**SUBJECT: MONTICELLO NUCLEAR GENERATING PLANT - ISSUANCE OF  
AMENDMENT NO. 180 TO RENEWED FACILITY OPERATING LICENSE  
REGARDING MAXIMUM EXTENDED LOAD LINE LIMIT ANALYSIS PLUS  
(TAC NO. ME3145)**

SAFETY EVALUATION BY THE OFFICE OF NUCLEAR REACTOR REGULATION  
REGARDING LICENSE AMENDMENT NO. 180 TO  
RENEWED FACILITY OPERATING LICENSE NO. DPR-22  
FOR MAXIMUM EXTENDED LOAD LINE LIMIT ANALYSIS PLUS (MELLLA+)  
NORTHERN STATES POWER COMPANY  
MONTICELLO NUCLEAR GENERATING PLANT  
DOCKET NO. 50-263

Figure 1 - MELLLA+ Operating Domain

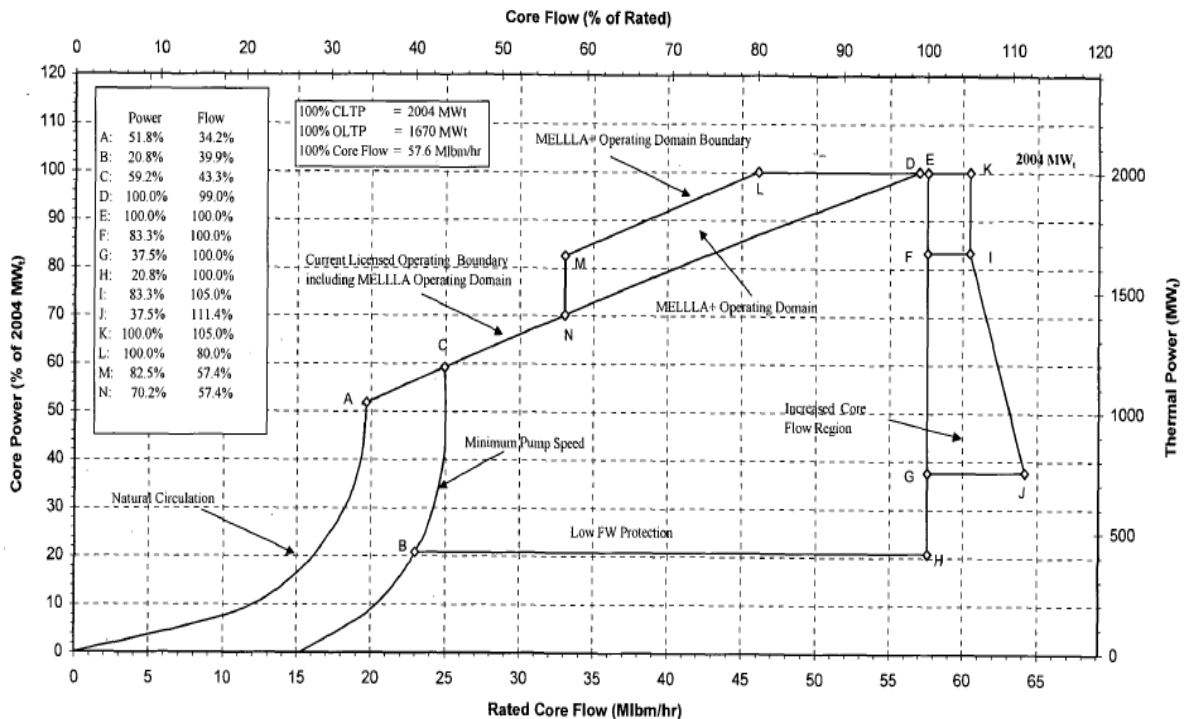
At the MELLLA+ low corner (Point M of Figure 1), the power-to-flow ratio is maximized and there is the potential to encounter void formation in the bypass region. In RAI-03, the NRC staff requested that the licensee provide an assessment of bypass void formation at point M. Furthermore, the staff requested that the licensee determine the effects of bypass void formation on local power range monitor (LPRM). The evaluation was performed and the bypass void fraction is expected to be less than 3.4 percent. This value is calculated using the ISCOR hot channel methodology computer code, which is conservative because it neglects cross flow between bundles in the bypass region; thus, the bypass voids are expected to be lower than the 3.4 percent value calculated. Proper LPRM calibration requires that the bypass void be maintained to a value less than 5 percent; as such, the NRC staff concludes that bypass voiding under MELLLA+ conditions in MNGP do not affect the LPRM instrumentation adversely.

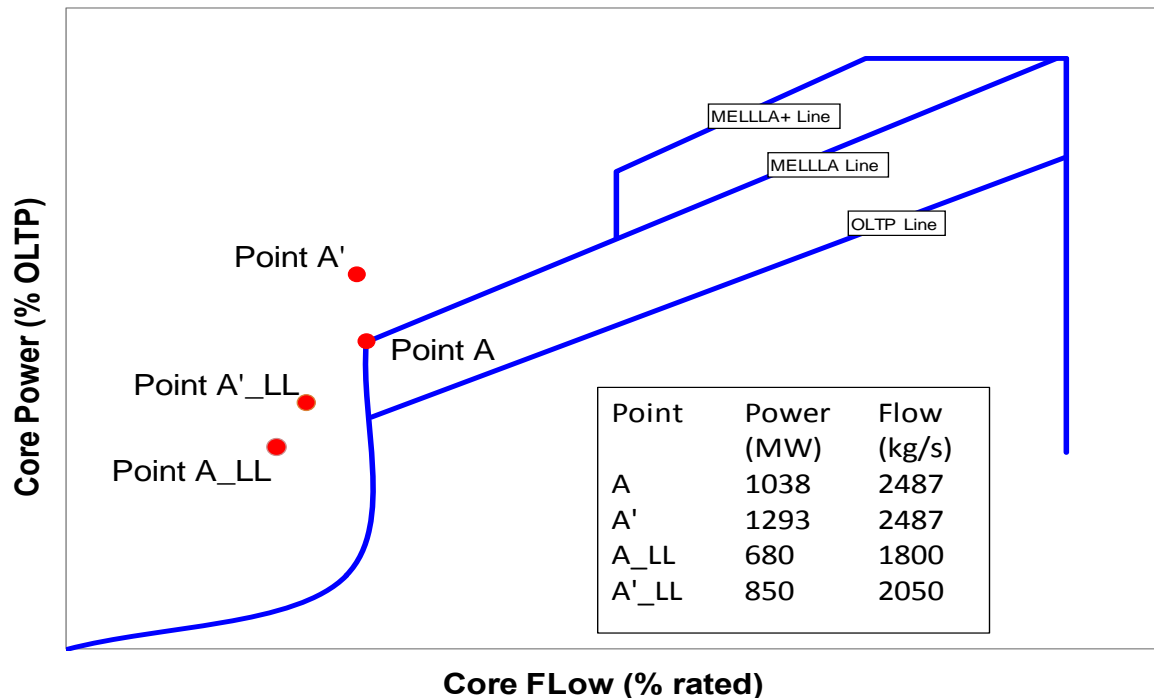
**RAI 9/11/13-2**

*Providing an ATWSI analysis is a MELLLA+ SER requirement per NEDC-33006P-A, Rev. 3, but the ATWSI analysis of record in the Safety Analysis Report (SAR) is based on the incorrect TRACG04 quench model. Provide documentation of the updated ATWSI analysis that includes assumptions, sequence of events, plots of relevant variables, and margin to acceptance criteria. Provide a justification for the assumptions used, with special emphasis on operator action timing (including actual timing values from simulator trials) and the type of initiating transient selection (i.e., Recirculation Pump Trip (RPT) versus Turbine Trip with Bypass (TTWBP)). A SAR revision or update would be adequate.*

Documentation of the updated ATWSI analyses was provided for both the TTWBP and the new limiting event, the 2RPT. Sequence of events, figures and description of the transient were provided as “changed pages” for the SAR. The NRC staff considers this RAI closed.

**Figure B-2: Operating Points Analyzed**

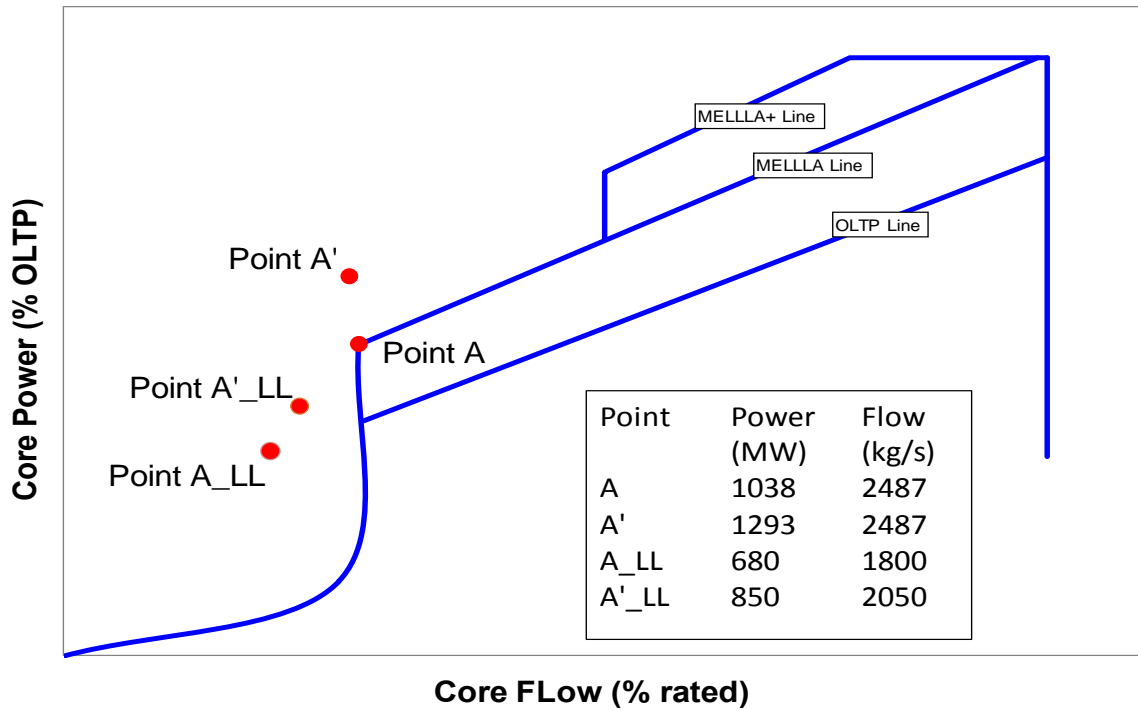
To determine the operating conditions of Point A' \_LL, a number of iterations were performed with LAPUR6. To determine the flow, a series of LAPUR6 calculations were performed as function of flow and the core delta-pressure was calculated. A reduction of downcomer water level to 2 feet below the spargers is equivalent to a 1.5 meter level reduction (at MNGP, the spargers are located at a reactor water level of -33 inches). At the reactor operating pressure, a reduction of 1.5 meters is equivalent to a pressure drop of approximately 0.1 bar. Thus, LAPUR6 runs were iterated until the core pressure drop calculated at Point A' (0.47 bar) was reduced to a value of 0.37 bar. To determine the operating power, the core-average void fraction was matched by iterating on the power level. Point A' has a core-average void fraction of 64.3 percent. The power of Point A' \_LL was changed until the same void fraction was achieved, indicating that the core would be critical (i.e.,  $k_{\text{eff}} = 1$ ) at this power level. Note that LAPUR6 computes the power-square average of the void, which is a better approximation in determining  $k_{\text{eff}} = 1$  than the non-weighted average.

Point A \_LL represents the low-level state for the pre-MELLLA+ core, where the downcomer water level has been reduced to 2 feet below the FW spargers and the core-inlet temperature is at saturation.

The result of the iterations shown in Figure B-2 and Table B-3 corresponds to a power of 850 MW and a flow of 2040 kg/s for point A'\_LL, and 680 MW and 1800 kg/s for point A\_LL.
